SITE PLAN

SOIL/SITE EVALUATION
for ON-SITE WASTEWATER SYSTEM

IMPROVEMENT PERMIT DENIAL

Re: Application for Improvement Permit for property located at 4509 WOODLAND AV , MINT HILL, NC 28227
Parcel No.: 13711270
Health Department File No.: SP26-097

PROPOSED PLOT PLAN

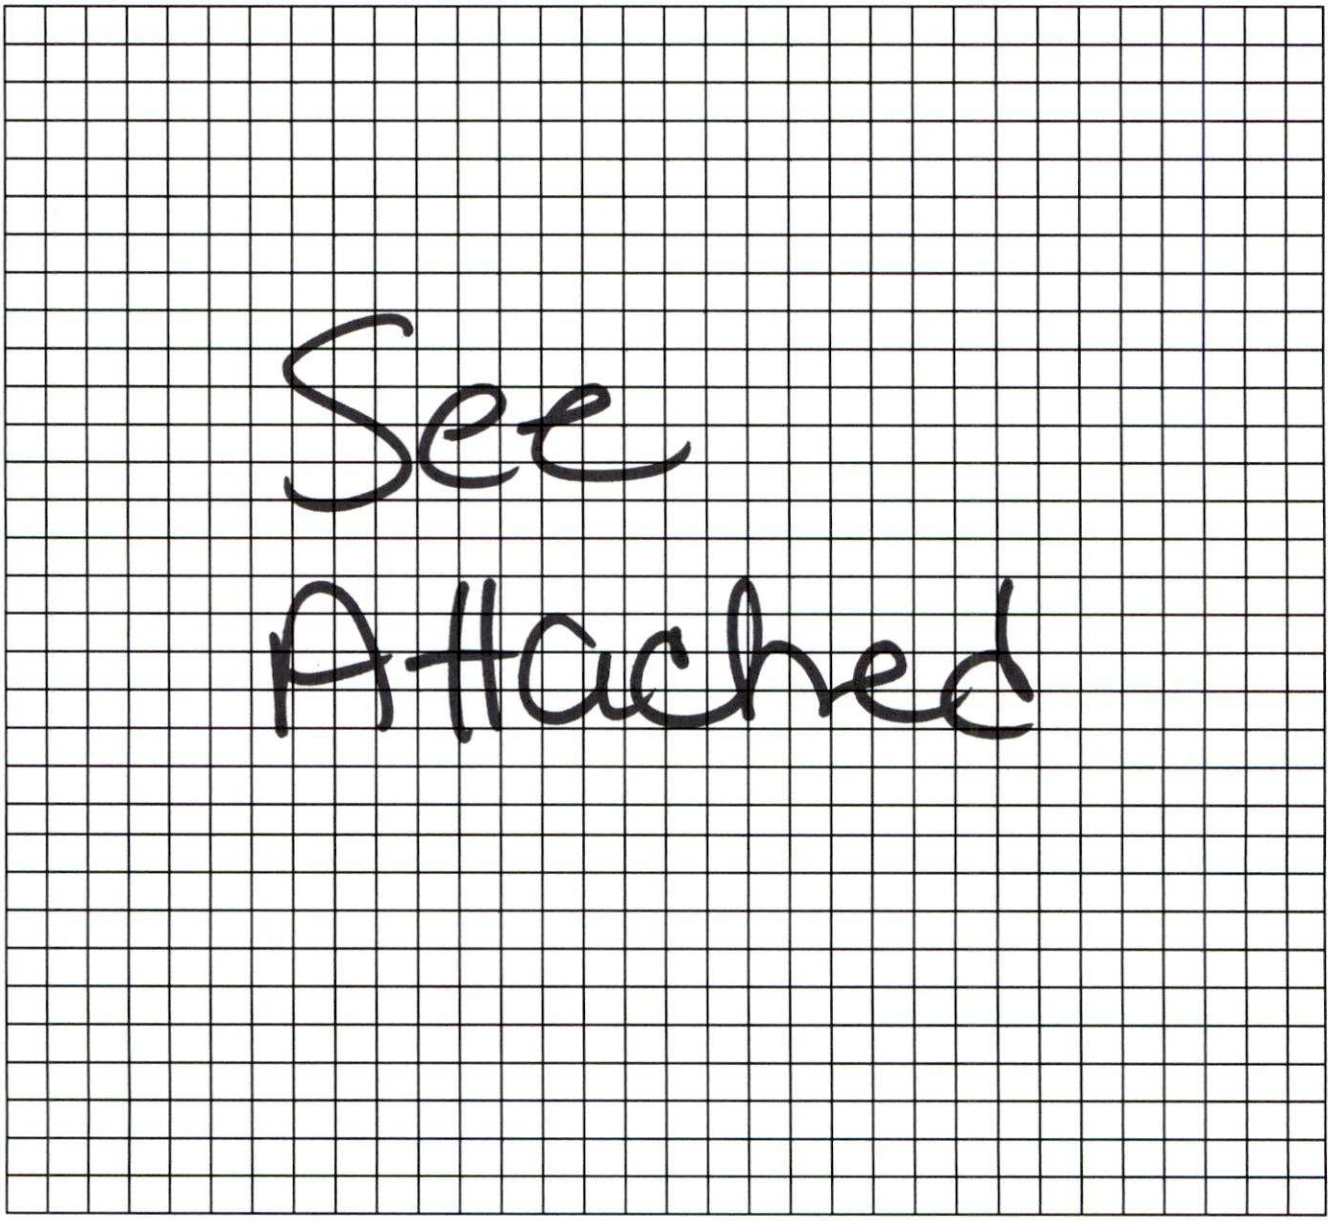
COMMENTS: There is insufficient space for a 5 BR SFR initial system and repair area with a design LTAR of 0.30.

Based on the criteria set out in 15A NCAC 18E .0501 through .0602, the evaluation indicated that the site is **UNSUITABLE** for an on-site wastewater system. Therefore, we must deny your request for an Improvement Permit. A copy of the site evaluation is enclosed. The site is unsuitable based on the following:

The site evaluation included consideration of possible site modifications, as well as use of all possible systems approved under 15A NCAC 18E. However, the Health Department has determined that none of the above options will overcome the severe conditions on this site. A possible option might be a system designed to dispose of sewage to another area of suitable soil such as off-site to additional property.
